**MECHANICAL ADDENDUM #M-2
NATIONAL DEFENSE, CFB BORDEN, ON
VICKERS KITCHEN AND DINING FACILITY
H-B147-4902/1
MAY 29, 2013**

The following document is hereby made a part of the Contract Documents.

DWG NO.: B147-4902/1 - 422 - MSK-11
 NUMÉRO DU DESSIN:

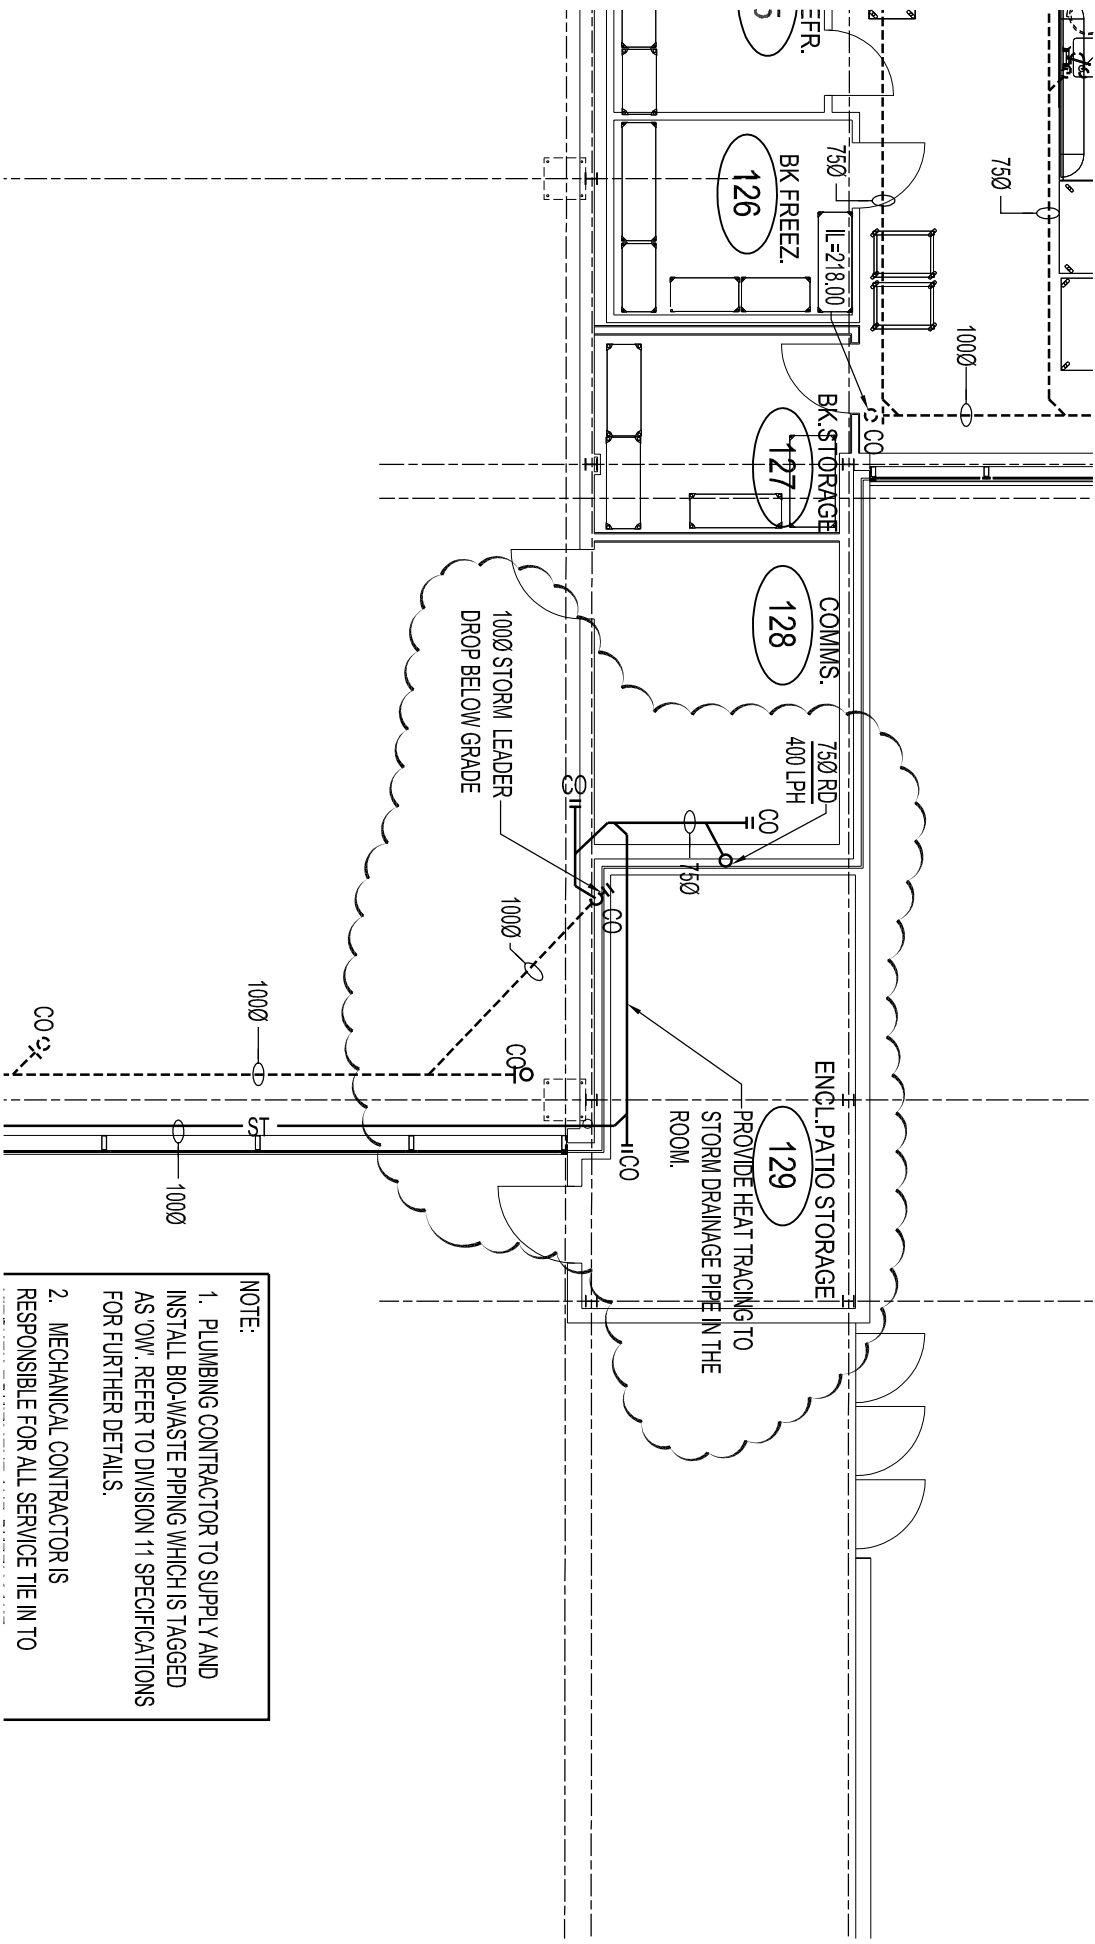
1. Delete the floor drains in the vestibule [101] and revise the sanitary drainage layout as shown on the attached Sketch MSK-2.
2. Revise the sanitary drainage layout to add a funnel floor drain and clean out near kitchen equipment #632 as shown on the attached Sketch MSK-3.
3. Revise the rain water drainage layout as shown in the attached Sketch MSK-11.
